Town of Smiths Falls
Public Works Operation Center
11 Air Care Drive
Smiths Falls ON, K7A 0B2

Date: July 29, 2026

PART 1 - General

- .1 This Addendum is issued prior to tender closing to provide revisions to the Contract Documents.
- .2 Such revisions shall become part of the Contract Documents and shall change the original contract documents only in the manner and extent stated.
- .3 Bidders shall take this Addendum into Consideration when preparing and submitting a Bid and shall acknowledge receipt of this Addendum in their bids.

1 GROUND OVERALL - MAIN BUILDING CODE COMPLIANCE PLAN
A081 1 : 100

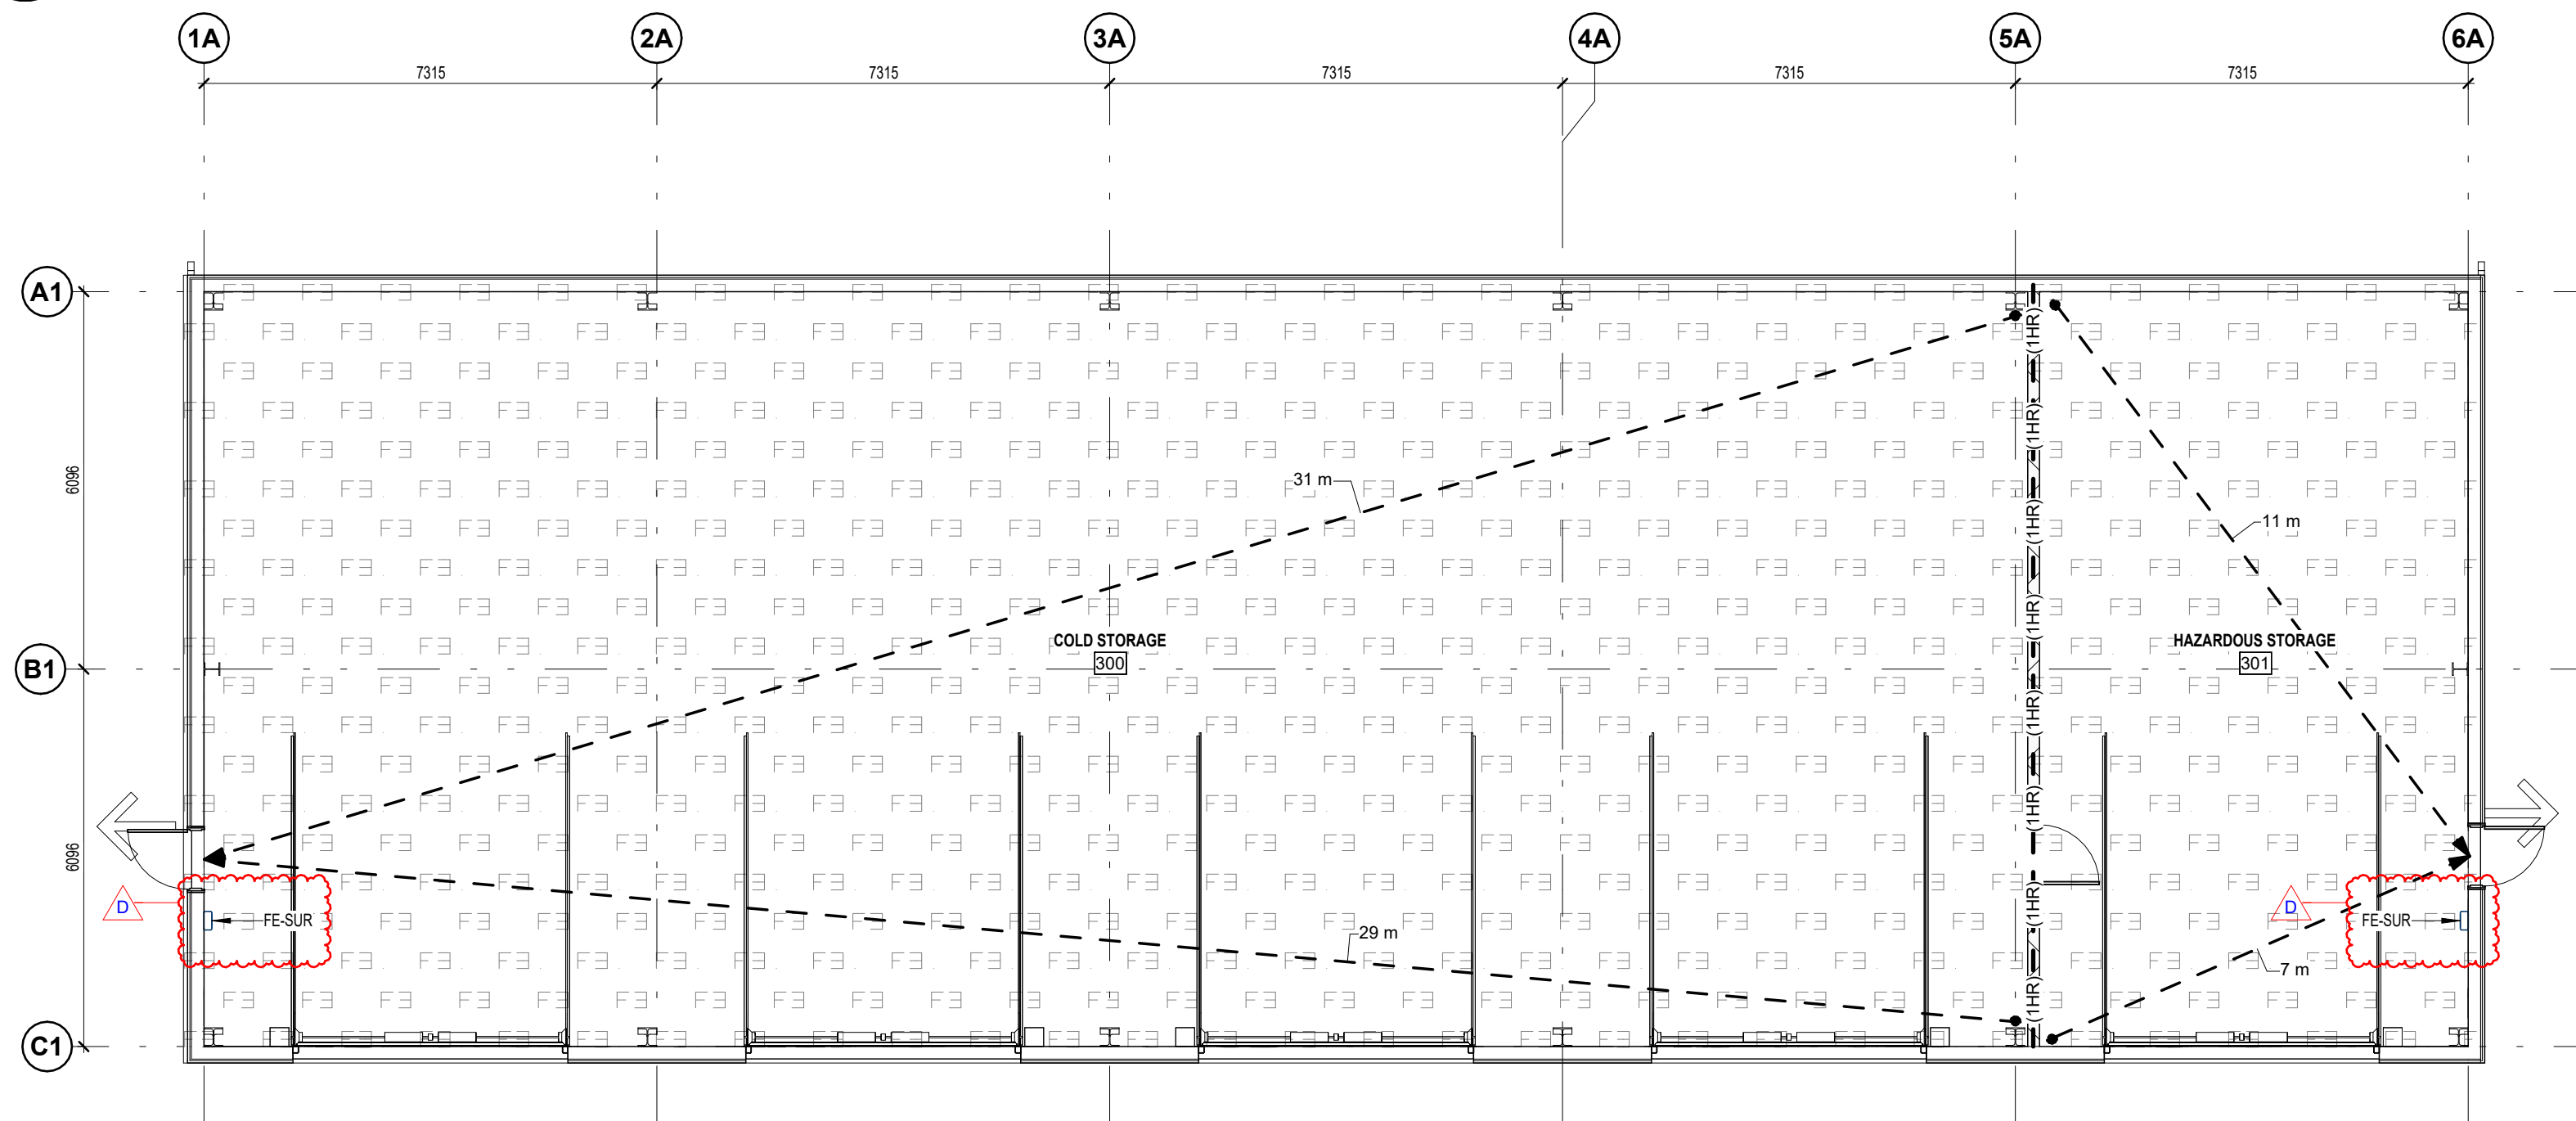
- .5 Refer to the attached Drawing A081 – CODE COMPLIANCE PLAN:
 - .1 ADD fire extinguisher locations and corresponding legend designations.
- .6 Refer to the attached Drawing A101 – SITE PLAN:

AD101

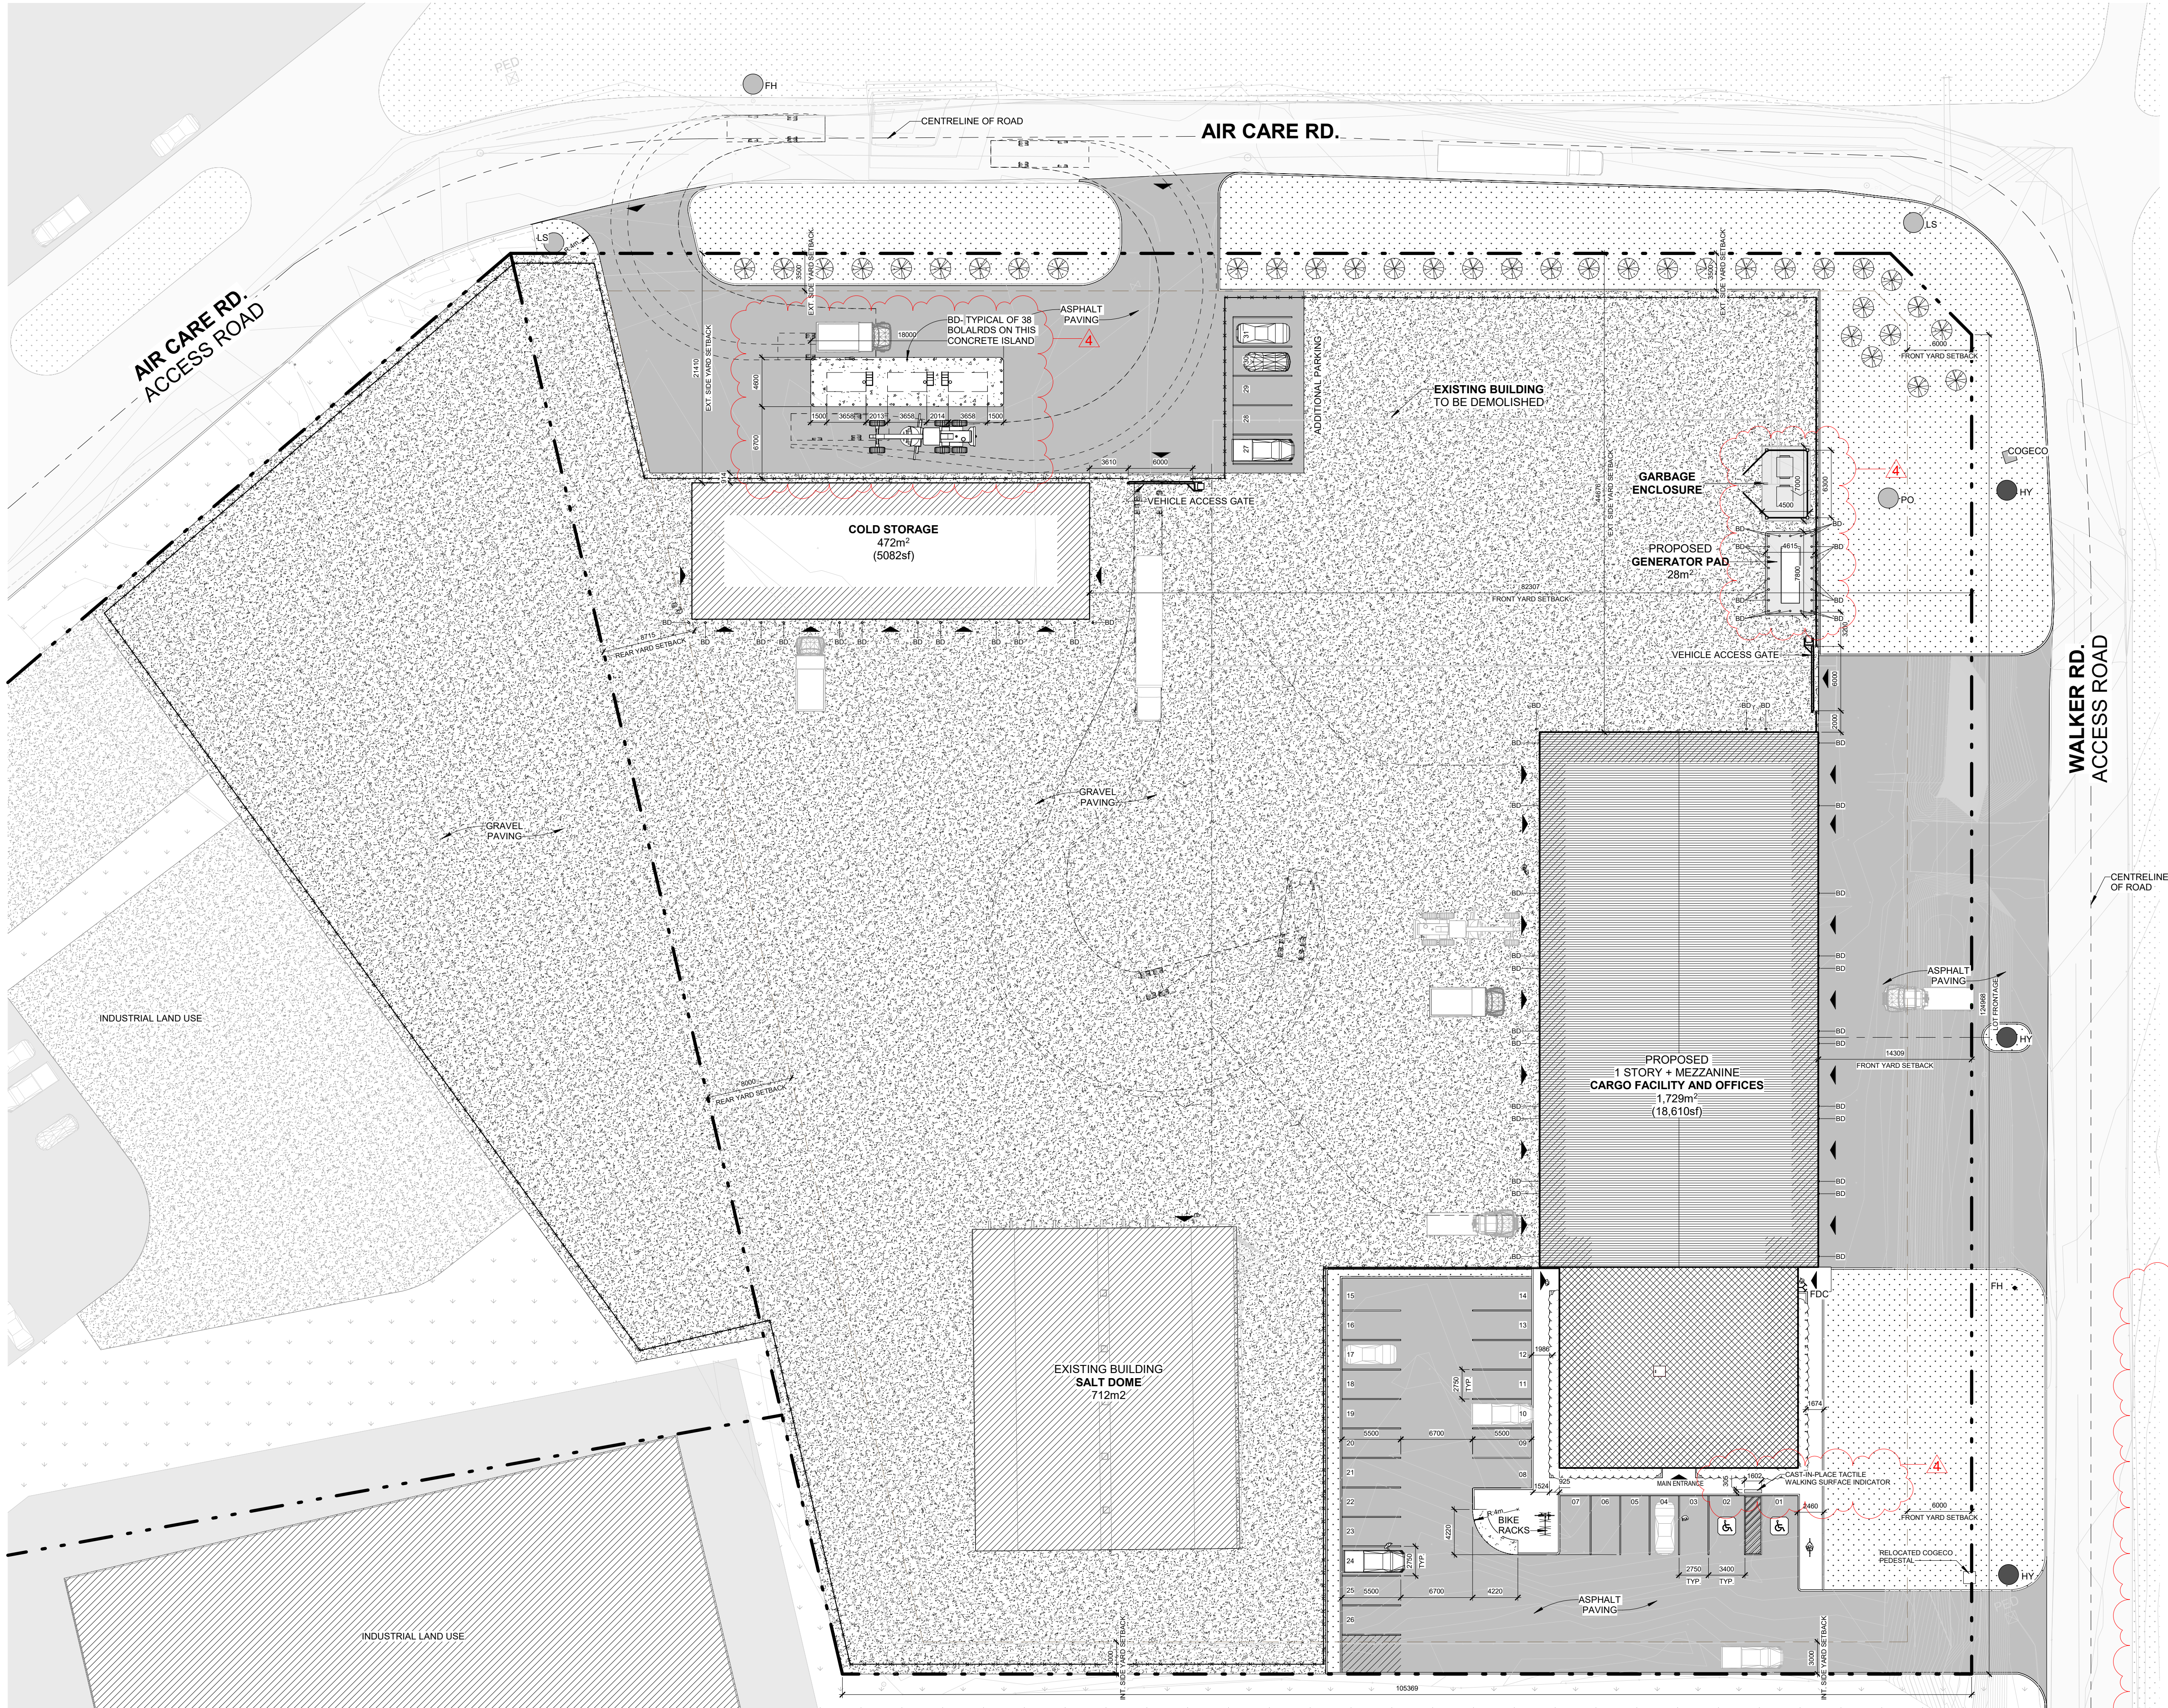
- .1 Refer to the attached Drawing AD101 – DEMOLITION SITE PLAN:
 - .1 ADD asphalt and curb demolition limits and associated notes.
- .2 Refer to the attached Drawing A020 – ASSEMBLIES HORIZONTAL & VERTICAL

1 BD - BOLLARD DETAIL
A101 1:30

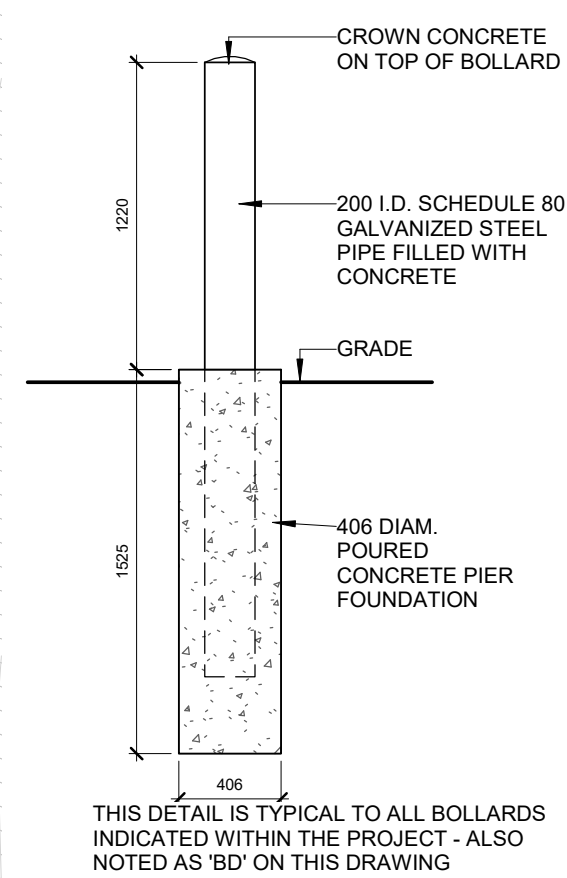
- .3 ADD Detail 1/A101 – Bollard Detail
- .7 ADD New Drawing A110 – LANDSCAPE PLAN
- .8 Refer to the attached Drawing A203 – ROOF PLANS:
 - .1 REVISE Roof slopes, sloped-insulation layout, roof designation, and associated dimensions at Roof Plan 1/A203 – Main Building.

1 REFLECTED CEILING PLAN - GROUND LEVEL - MAIN BUILDING
A301 1 : 100

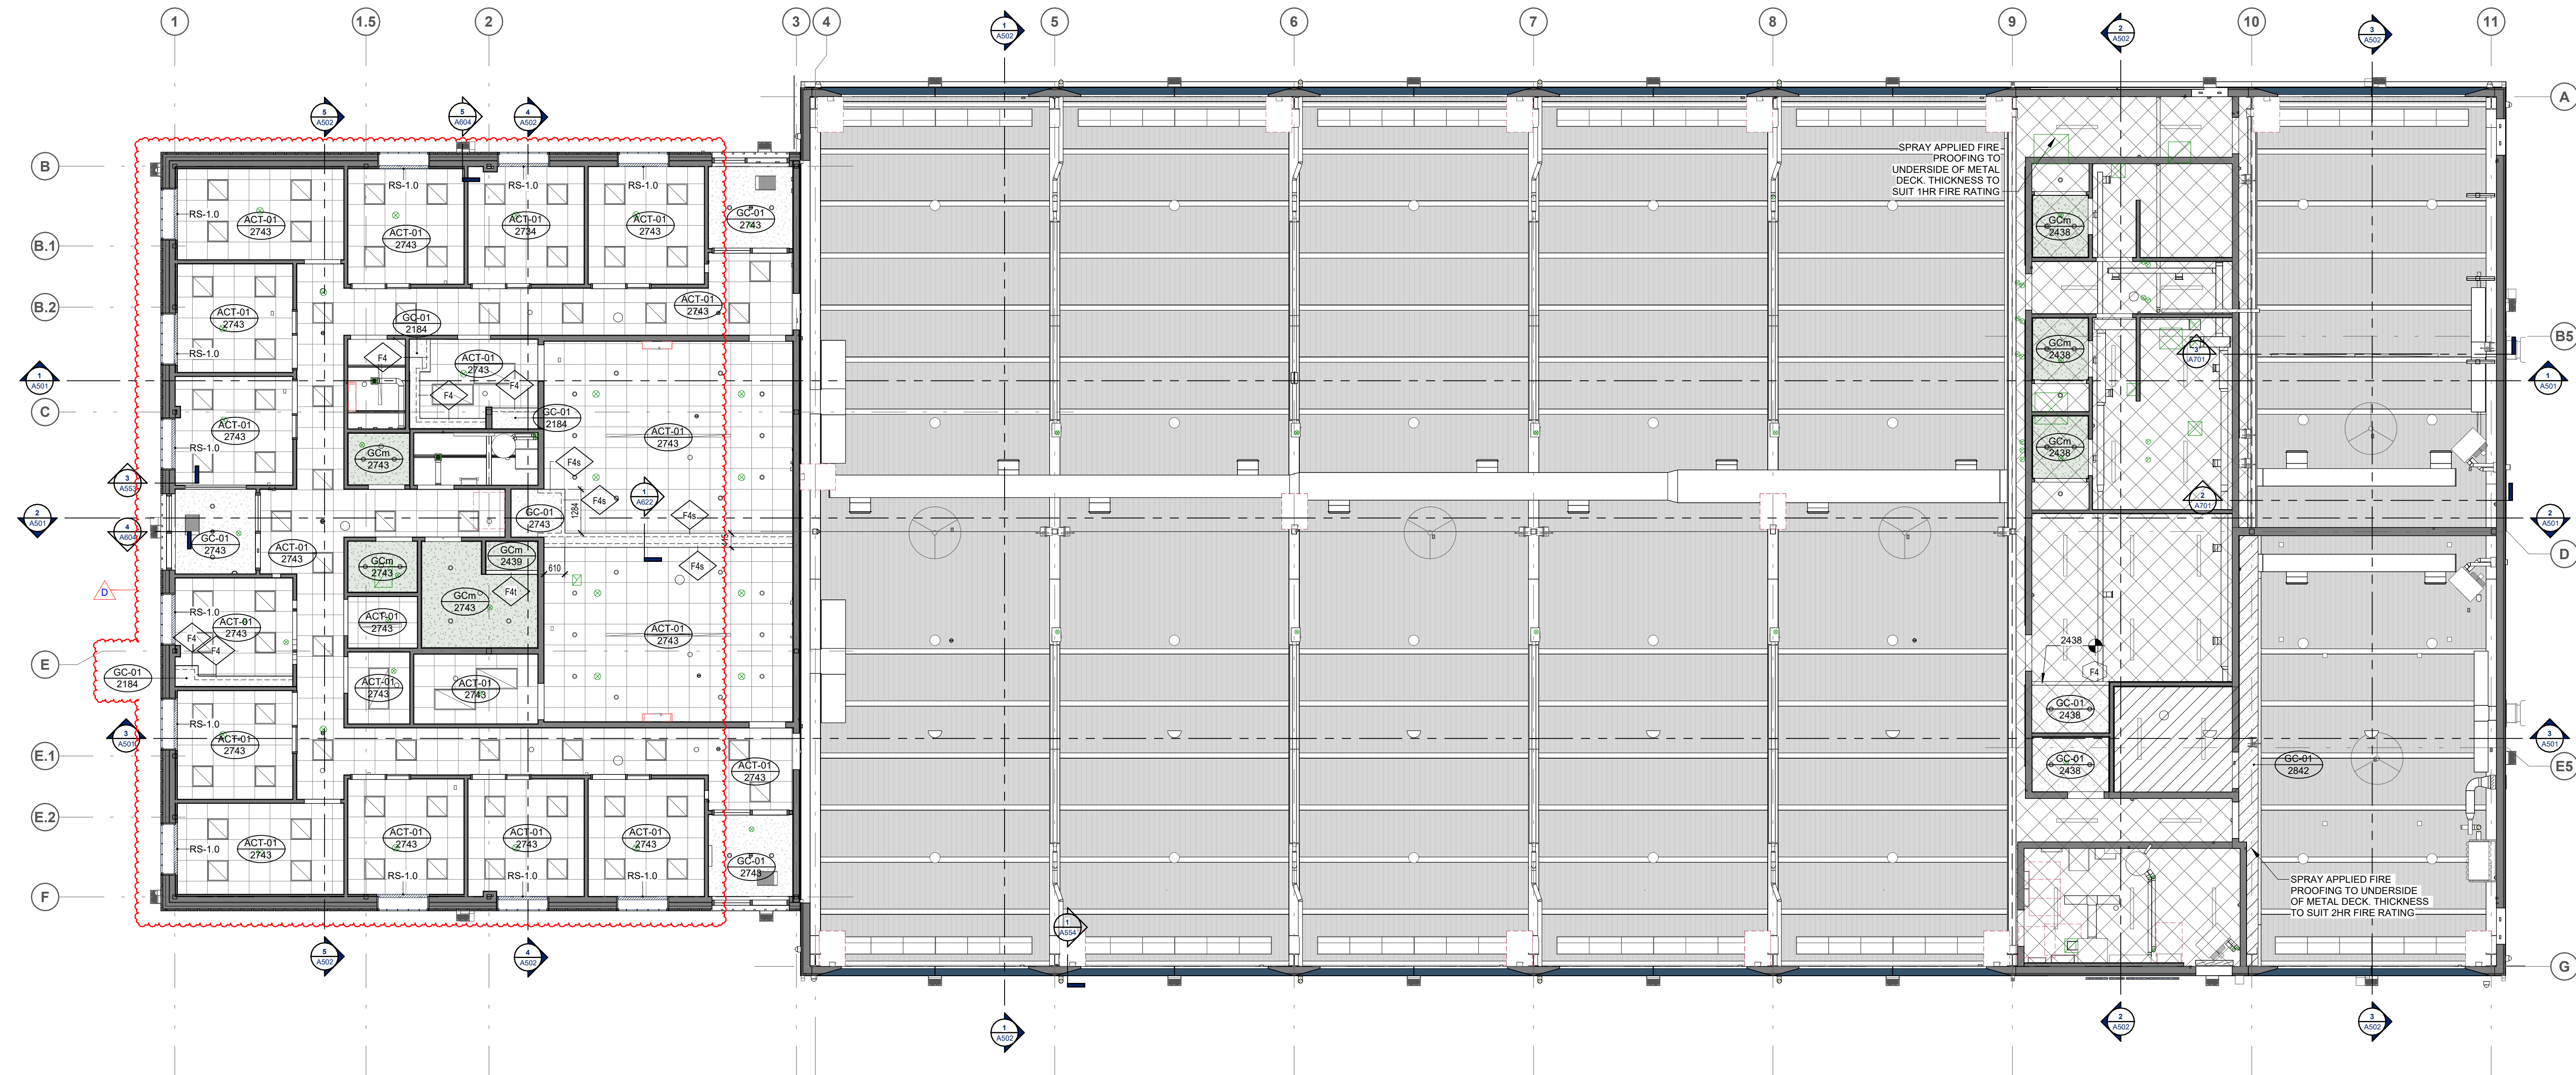
- .9 Refer to the attached Drawing A301 – REFLECTED CEILING PLAN – MAIN BUILDING:
 - .1 ADD Type GC-01 bulkhead with associated Type F4 vertical faces in Copy/Equip. Room 106.

- .2 REVISE the ACT-01 ceiling layout and lighting fixture locations to accommodate the new bulkhead.
 - .3 REVISE Type GC-01 bulkhead and associated Type F4 vertical faces in Kitchen 125.

- .4 ADD Type RS- 1.0 roller shades at all windows. Refer to Specifications 12 24 13. Height and width of roller shades are to match proposed windows in each location.
